Bulker Q&As and CIs on the IACS CSR Knowledge Centre

KC#609-1

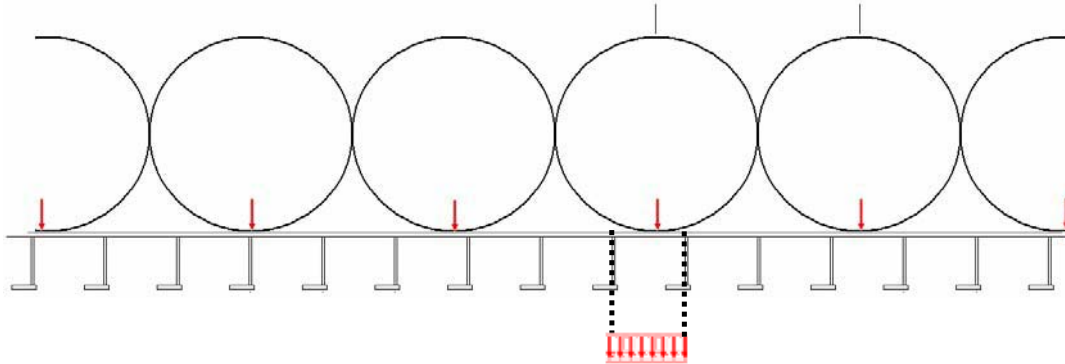
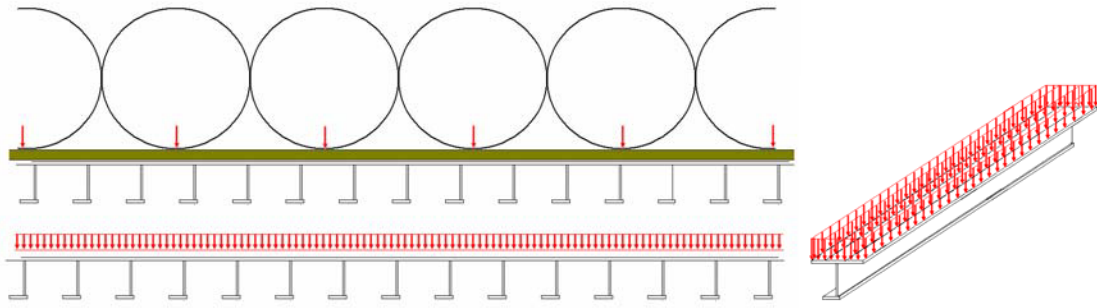
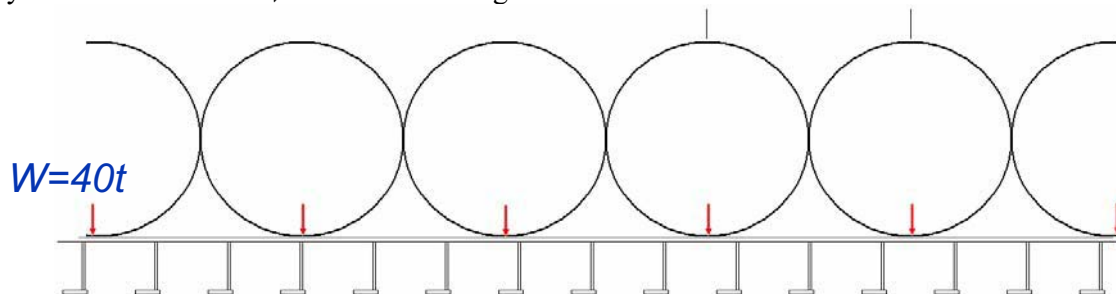
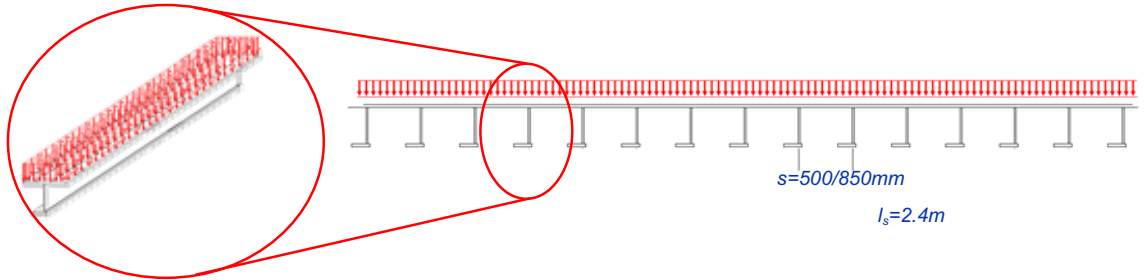
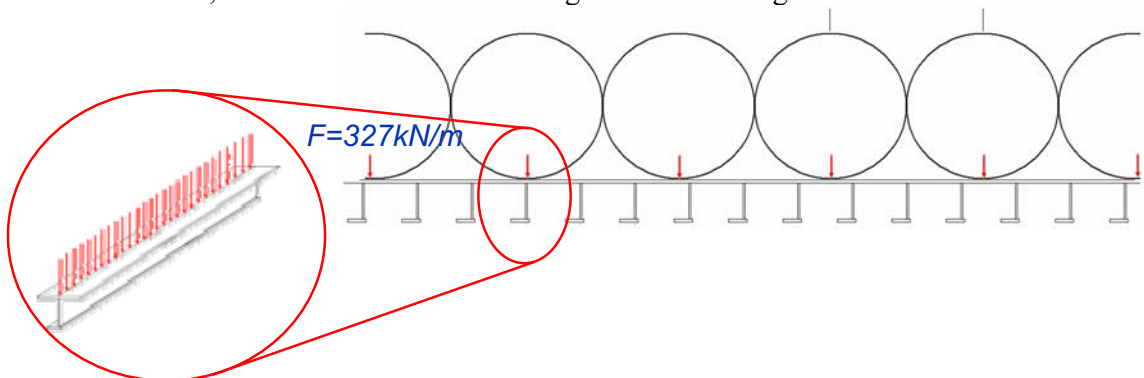
RCP on evenly distributed load according to Ch. 6 Sec. 1 [2.7.1] and Sec. 2 [2.5.4] Steel coil loading

DNV interpretation of the text is: If the bottom coil is supported by 6 or more dunnages going transversally, the load from the coil on the inner bottom can be simplified to a uniform pressure. See below figure.

The load is then transferred between the longitudinals by the wooden dunnages. This requires the dunnages to be extremely stiff. It is our opinion that this assumption is wrong and that the pressure load should be changed to a line load on the stiffener. We have performed a small comparison case below in order to elaborate our understanding of the problem.

Figure 1 Steel coil deforming in to the wooden support

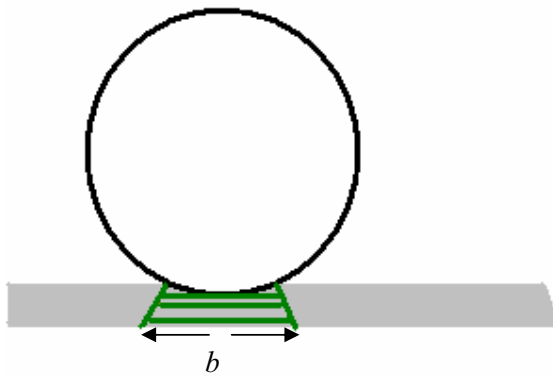
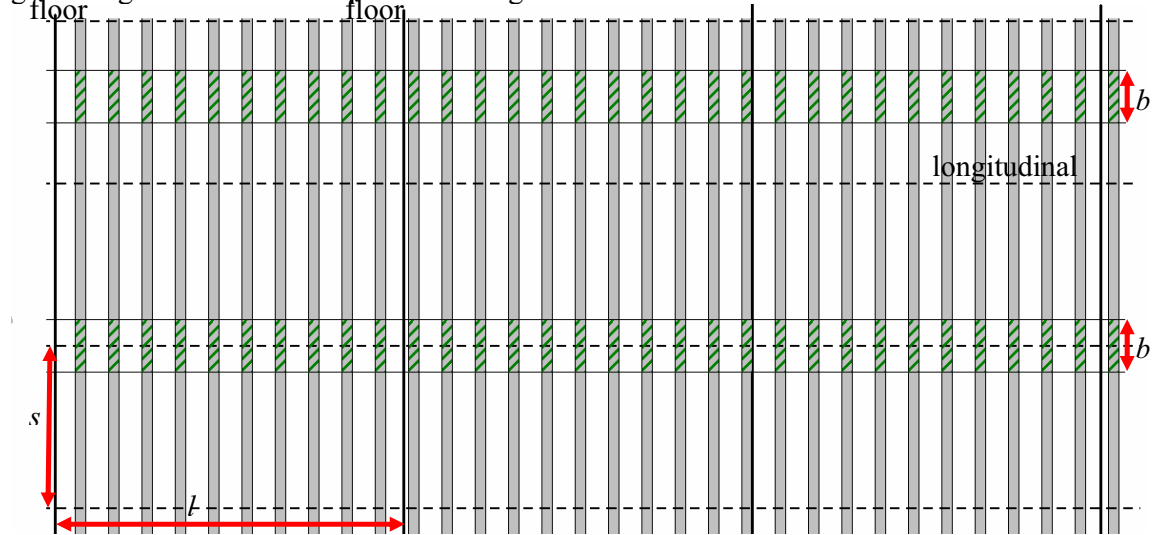
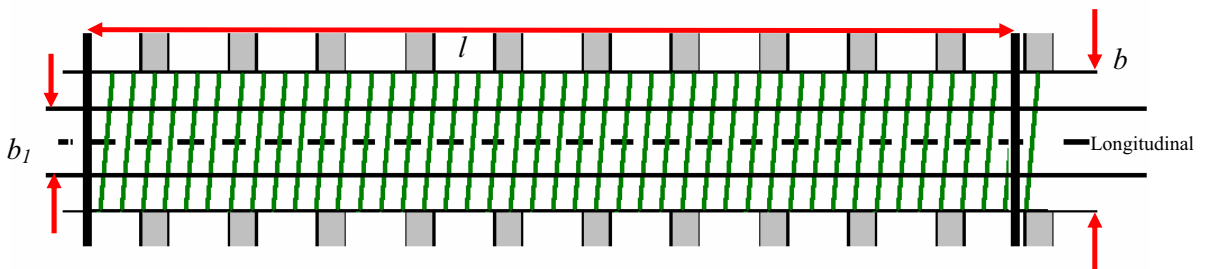
It is assumed that the diameter of the coils is larger than two primary frame spaces, $D > 2s$. The steel coil is loaded on a wooden support, which is soft compared to the steel coil. The coil will deform in to the wood and spread the load over a small distance b of the inner bottom plating, see Figure 1.

As described earlier, the coils will be loaded randomly within the double bottom. The diameter, D , of the coils do not match the primary longitudinal spacing. Consequently, there will always be coils meeting a longitudinal and coils at the middle of a plate field. The first

When the number of dunnages is large, the pressure from the steel coils on the wooden support will converge towards a uniform pressure within the breadth b , see Figure 2.

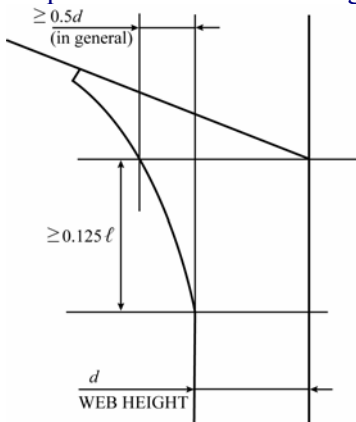
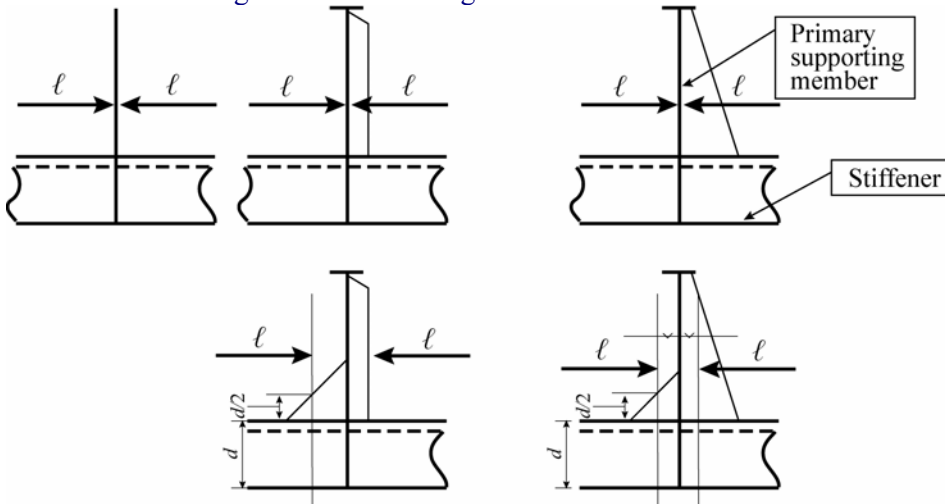
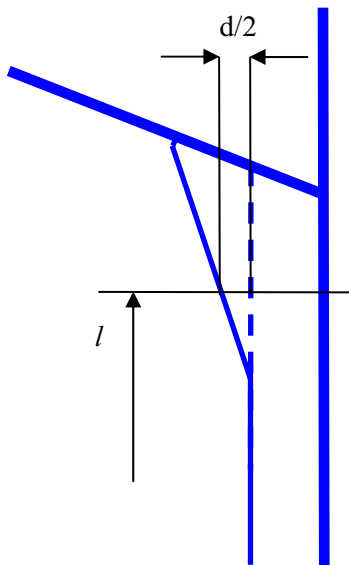
Reference is made to requirements for frames of single side bulk carrier subject to ballast pressure. Ch. 6 Sec. 2 [3.3.1]. IACS KC 457/215/356

In KC#356 it is shown that for $l_{eff}=l$ the sectional modulus for [3.2.3]= $2x$ [3.3.1]. In practice this correspond to an m-factor of $m_{mid}=10$ and $m_{end}=5$, which is very conservative. Note also that $m=10$ is normally the end moment of a vertical stiffener.

In order to accommodate the equation [3.2.3] we see designs with long and slender brackets for side frame as shown in the figure below.

The brackets give large reduction to effective length. DNV is concerned about this development as the length may be reduced to an extent so that the mid span sectional modulus is below originally required by DNV Rules.

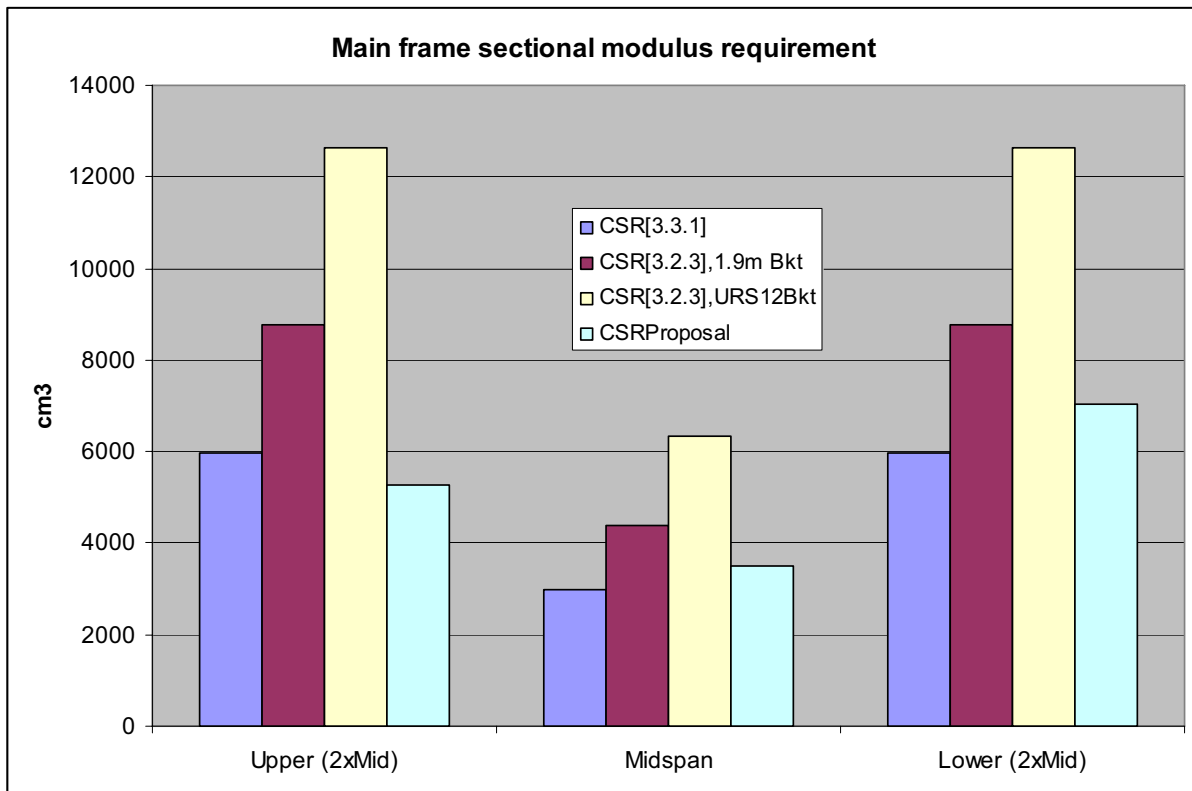
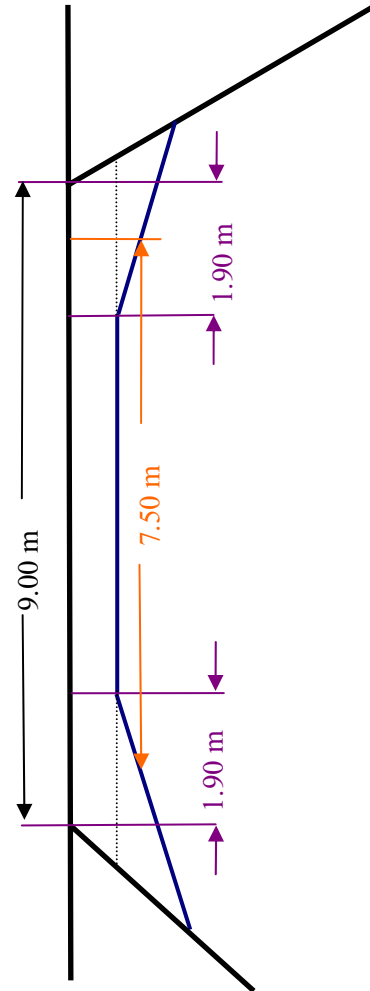
Sectional modulus calculation:

CSR _[3.3.1]	CSR _[3.2.3] BKT 1.9m	CSR _[3.2.3] , URS12Bkt	CSR _{Proposal}	
Upper (2xMid)	5973	8779	12642	5267	cm ³
Midspan	2987	4390	6321	3512	cm ³
Lower (2xMid)	5973	8779	12642	7023	cm ³
